CE1-13, Part I

C101.2, C101.3, C101.3.1 (NEW), C101.3.2 (NEW), C101.4.2, C101.4.3, C101.4.6 (NEW), C101.4.6.1, C101.4.6.2, C101.4.6.3, C101.5, C102, C102.1, C102.1.1, R101.2, R101.3 (IRC N11101.2), R101.3.1 (NEW) (IRC N1101.2.1 (NEW)), R101.3.2 (NEW) (IRC N1101.2.2 (NEW)), R101.4.2, R101.4.3 (IRC N1101.3), R101.4.6 (NEW), R101.4.6.1, R101.4.6.2, R101.4.6.3 (NEW), R101.5 (IRC N1101.5 (NEW)), R102, R102.1, R102.1.1 (IRC N1101.7)

Proposed Change as Submitted

PART I – IECC-COMMERCIAL PROVISIONS

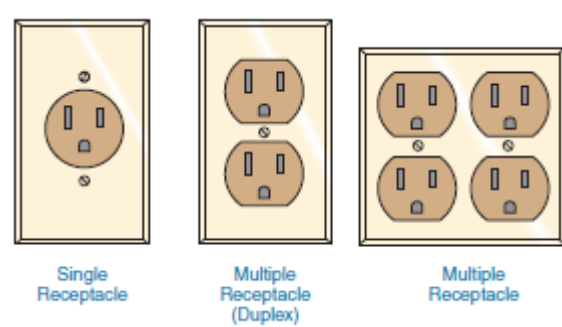
C405.8 Automatic receptacle control. Automatic controls shall be provided for at least 50 percent of the 125 volt 15- and 20-ampere receptacles in private offices, computer classrooms, individual workstations and receptacles associated with branch circuit feeds that are installed to supply electrical power to modular furniture in such spaces.

Use the following guidelines for determining how to meet the requirement:

- If the receptacle outlets are single receptacles then 50 percent of them must be controlled. It may be necessary to add controlled receptacles.
- If the receptacle outlets are duplex receptacles then the devices may be split wired with one half being controlled. Alternatively additional controlled duplex receptacles could be added nearby.
- If the receptacle outlet consists of multiple receptacles then the devices may be split wired as above or half of the receptacles may be separately wired to achieve the 50 percent controlled requirement.
- In a defined workspace such as with modular partitions, 50 percent of the receptacles in each area accessible to the occupant must be controlled, i.e. one area would be above the desktop and another area might be below. See receptacle definitions below.

FIGURE C405.1
DAYLIGHT ZONE ADJACENT TO FENESTRATION IN A WALL

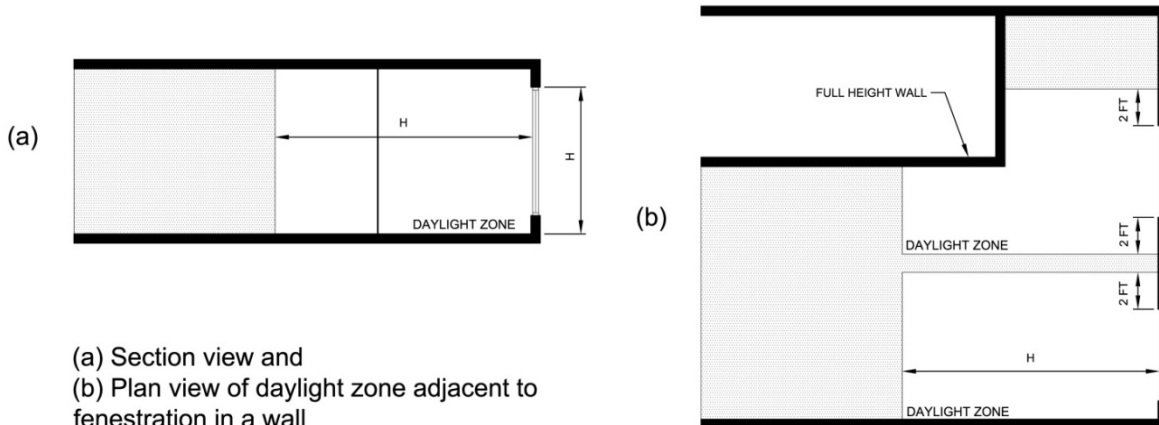
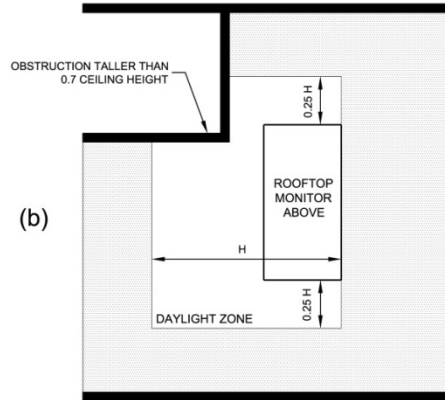
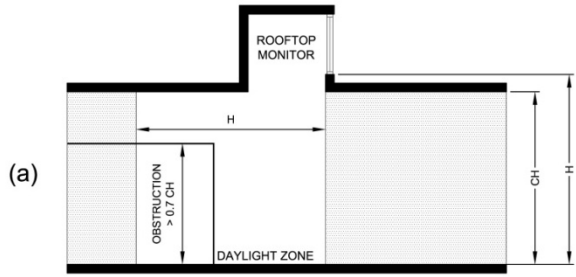
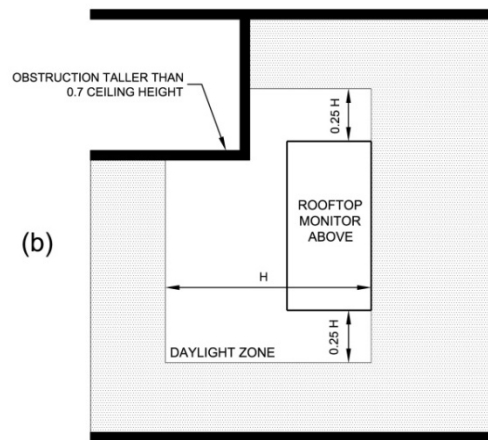
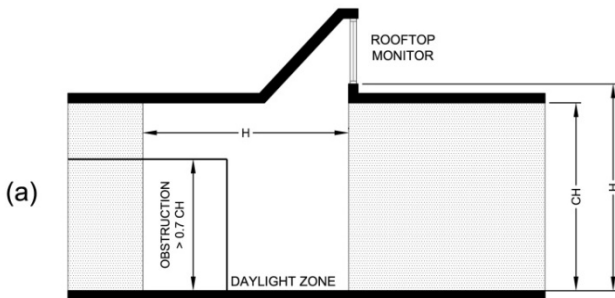
C405.2.2.3.3 Toplight daylight zone. The toplight *daylight zone* is the floor area underneath a roof *fenestration* assembly which complies with all of the following:

1. The *daylight zone* shall extend laterally and longitudinally beyond the edge of the roof *fenestration* assembly to the nearest obstruction that is taller than 0.7 times the ceiling height, or up to 0.7 times the ceiling height, whichever is less, as indicated in Figure C405.4;
2. No building or geological formation blocks direct sunlight from hitting the roof *fenestration* assembly at the peak solar angle on the summer solstice; and
3. Where located in existing buildings, the product of the *visible transmittance* of the roof *fenestration* assembly and the area of the rough opening of the roof fenestration assembly, divided by the area of the daylight zone is no less than 0.008.
